March 31, 2026

**Re: 2026 Waterline Improvements (PR#48-2026, SD-22-358)
Falls City (PWS ID#00297)
Conditional Approval**

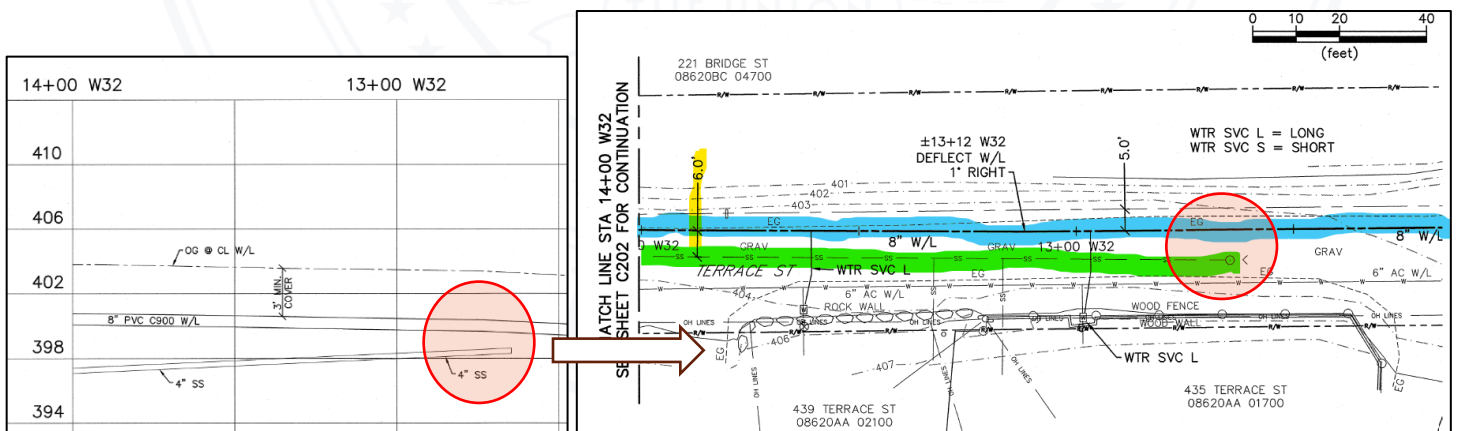
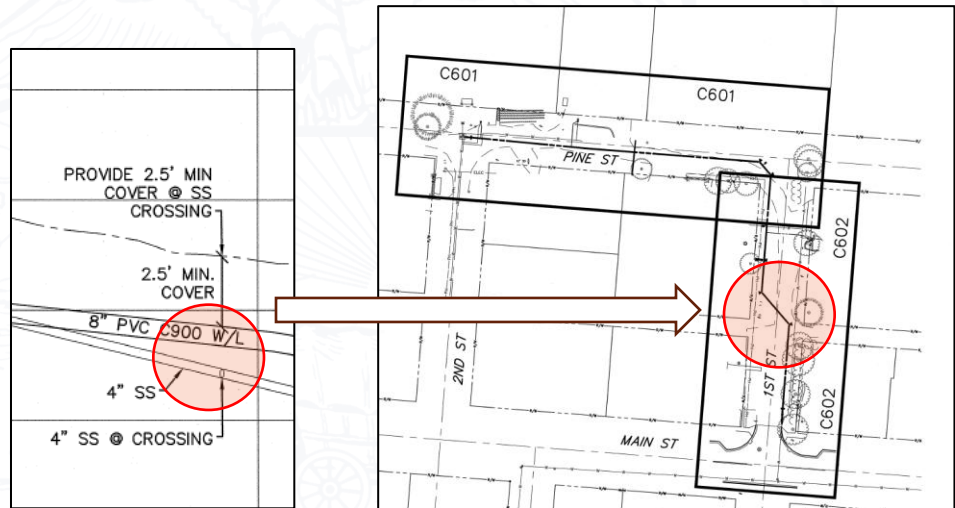
1. All items in contact with potable water must meet NSF Standard 61 or equivalent.
2. The design must allow for 20 psi to be maintained at all service meters.
3. As indicated in construction note #77 on drawing G003, water and sewer line crossings conform to OAR 333-061-0050(9). Waterlines running parallel to sewer lines must also meet OAR 333-061-0050(9) – see enclosure. There are several close sewer line crossings and a few narrow lateral separations, examples of which are shown below.
